**Certificate of Appropriateness Application**  
**BAR 07-11-07**  
**400 East Jefferson**  
**TM 53 P 46**  
**Candace DeLoach**  
**Renovation**

**CITY OF CHARLOTTESVILLE  
BOARD OF ARCHITECTURAL REVIEW  
STAFF REPORT  
November 20, 2007**

**Certificate of Appropriateness Application  
BAR 07-11-07  
400 East Jefferson  
TM 53 P 46  
Candace DeLoach  
Renovation**

PROPOSED PANEL SHUTTERS  
O COURT SQUARE

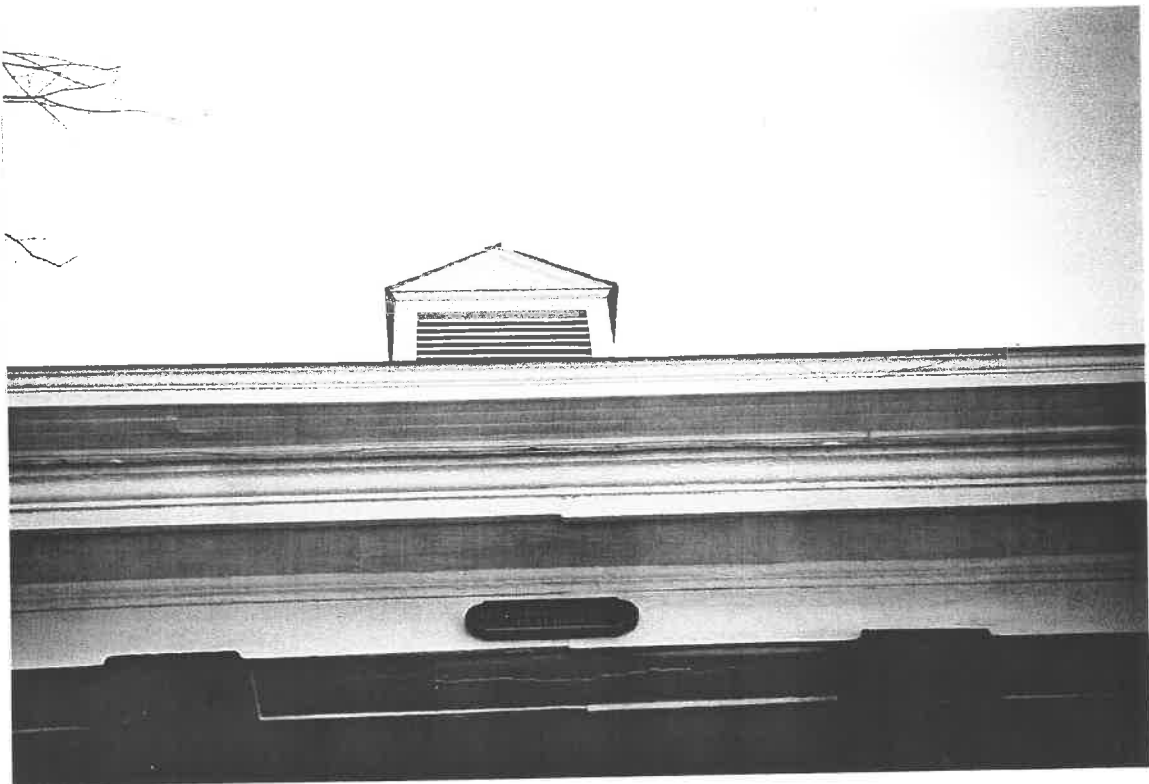
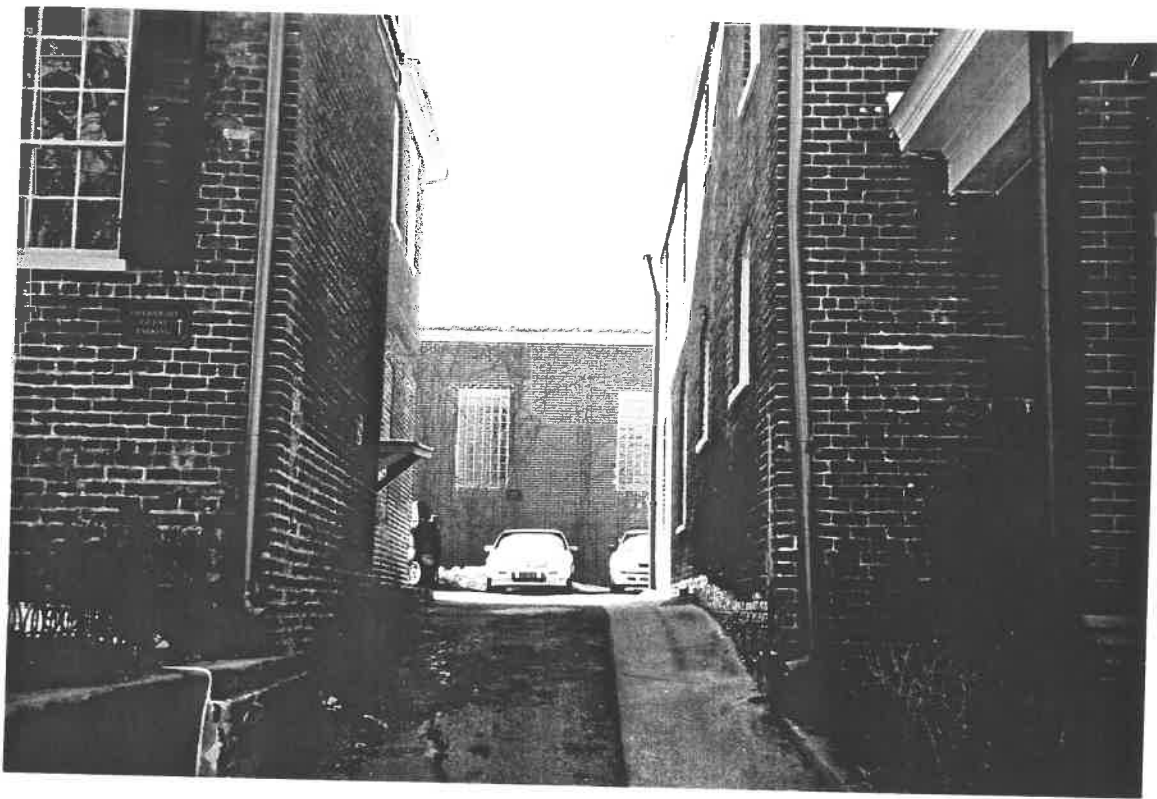
12. Add original panel type wood shutters on upper front and all 4<sup>th</sup> Street side windows (but not on dormers or doors).

It is unknown whether this house originally had shutters. Adjacent buildings on E. Jefferson Street and on 4<sup>th</sup> Street have shutters. The windows look elegant without them. However, they are easily added and removed. The guidelines recommend shutters if they are compatible with the style of building or neighborhood. They should be wood, mounted on hinges, and should be sized to cover the window if closed. The BAR previously (4-15-2003) allowed them only on the 2<sup>nd</sup> floor windows on the E. Jefferson Street side. Not all the windows on 4<sup>th</sup> Street are spaced to accept two shutters between them.

Approved (5-1) item #12 to allow panel wood shutters, dimensioned to fit the windows and with operable hardware, on the upper front and all of 4<sup>th</sup> Street windows, but not on doors or dormers.

PROPOSED DECORATIVE  
BRACKETS TO SUSPEND  
GAS LANTERN AND TO  
CREATE AN ARCH BETWEEN  
TWO BUILDINGS

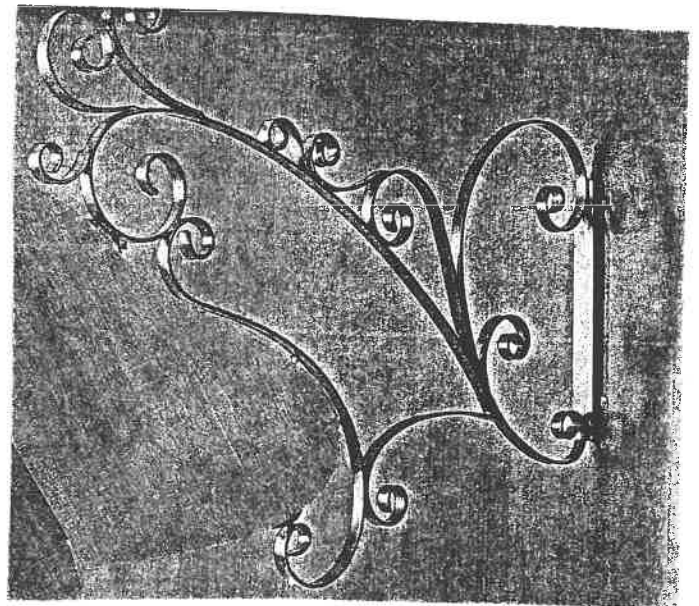
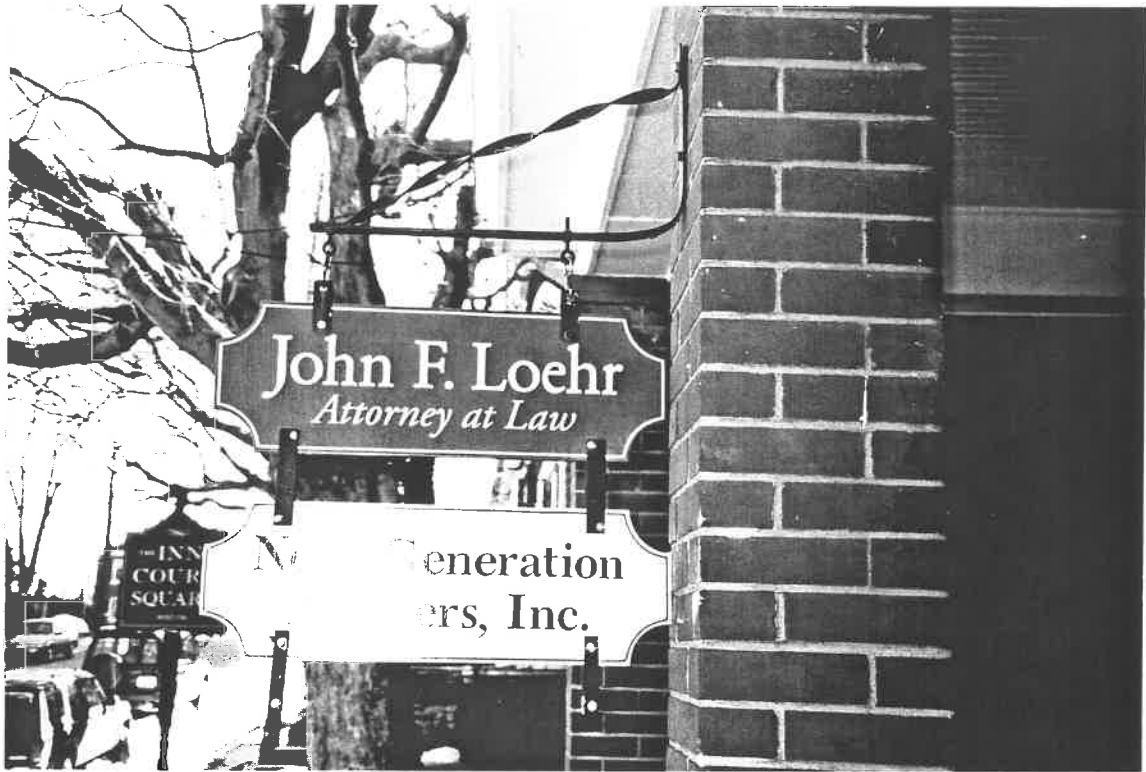
16. Suspend gas lantern from decorative brackets to create an arch above shared driveway between two buildings.

The BAR approved this request on 3-18-2003 subject to confirmation by the BAR how the gas line fits into the design.

Failed to approve (3-3) item #16 decorative arch with gas lantern between buildings. One member objected to the concept; two others objected to the ornateness.

PROPOSED SIGNAGE BRACKET

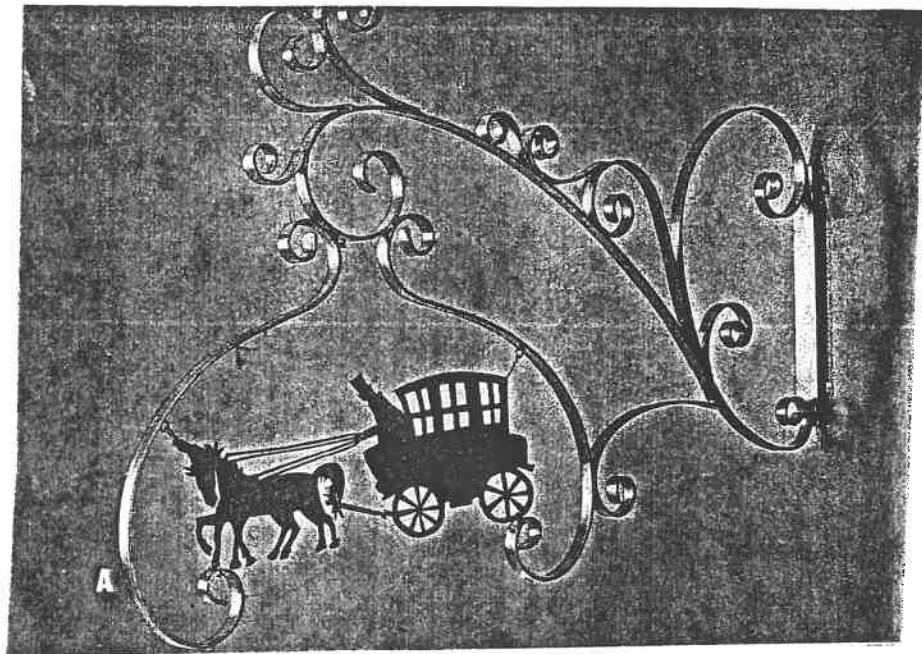
17. Mount decorative iron brackets on building for shop signage.

The BAR approved this request on 3-18-2003. All signs require a separate sign permit, to be approved by the zoning administrator and, in an ADC district, BAR staff.

Approved (4-2) item #17 signage brackets.
